**N6762A-02**

**S E R V I C E N O T E**

**N6762A Precision DC Power Module**

**Figure 1.** Mainframe is unable to detect Option 2UA

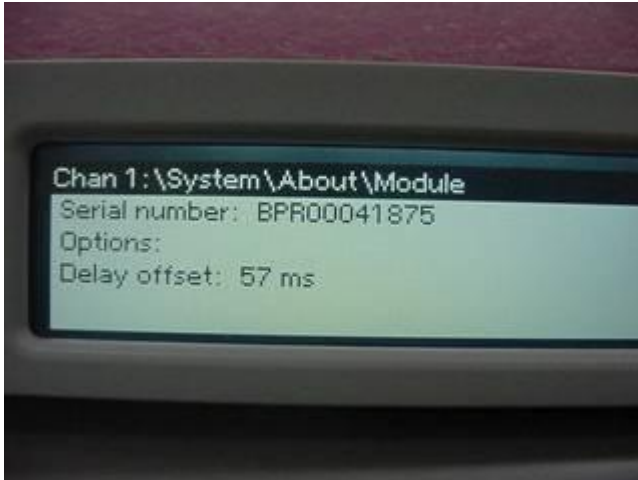
All N6700A, N6700B, N6701A and N6702A mainframes with a firmware revision lower than C.02.18 have the potential to not detect the 2UA Option during a query for the option information from the mainframe's menu as well as using the SCPI command SYST:CHAN:OPT? (@<chanlist>).

First, check the firmware revision of the N6700A, N6700B, N6701A or N6702A mainframe. To do this using one of the IO interfaces, send the “\*IDN?” query.

Menu -> System -> About -> Frame. It will be listed under “Firmware revision.” If the firmware revision is C.02.18 or higher, the unit has already been upgraded and no further upgrade is required.

If the firmware revision is older than C.02.18 then the firmware must be upgraded. All files, programs, and instructions required to upgrade the firmware are located at the following website:
